# Beechcraft SERVICE BULLETIN

Model: 23

No. 5

**SUBJECT:** INSTALLATION OF AN21-10 BOLTS IN AILERON CABLE-CHAIN CONNECTING LINKS.

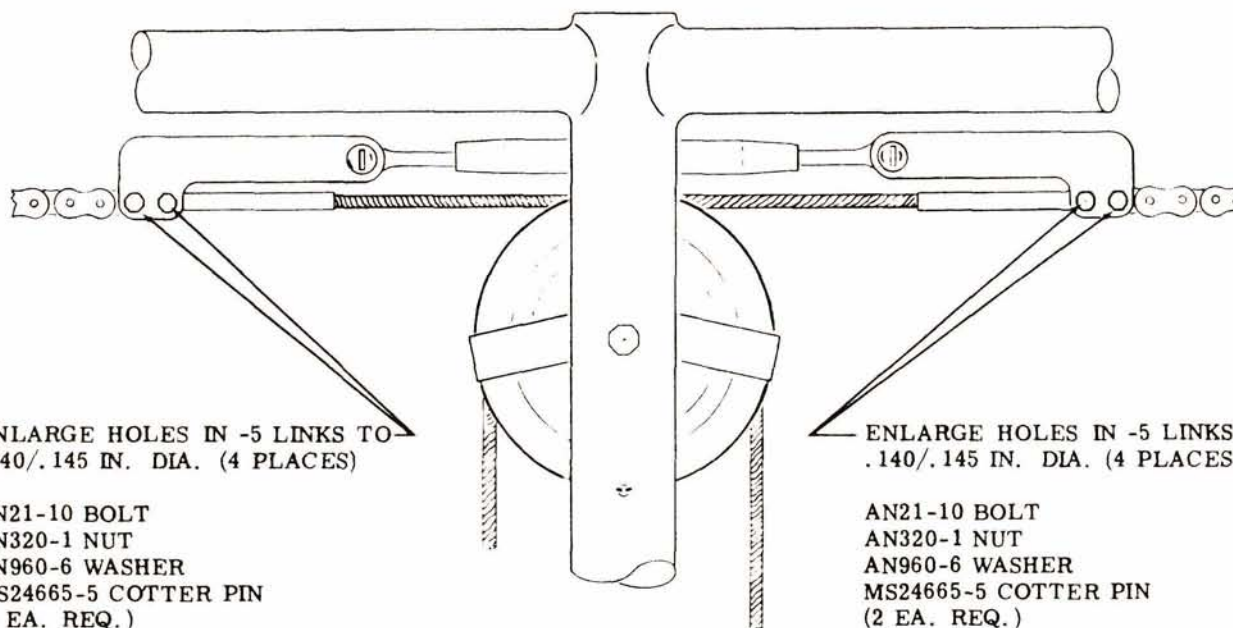
**DESCRIPTION:** This modification consists of removing the two retaining pins in each pair of aileron cable-chain connecting links and replacing the pins with AN21-10 bolts. Rework may be accomplished as follows:

1. Locate the two pairs of 169-524040-5 aileron cable-chain connecting links on the control column crossbar

behind the instrument panel. (See illustration).

3. Enlarge the hole from which the retaining pin was removed to .140/.145-inch diameter.

4. Insert an AN21-10 bolt into the .140/.145-inch diameter hole and engage the cable terminal with the bolt while removing the retaining pin from the terminal and opposite link. Again make certain that the cable terminal is not released.

5. Drill out the retaining pin hole in the opposite link to .140/.145-inch diameter and insert the AN21-10 bolt.

6. Secure the AN21-10 bolt with an AN320-1 nut, AN960-6 washer, and an MS24665-5 cotter pin.
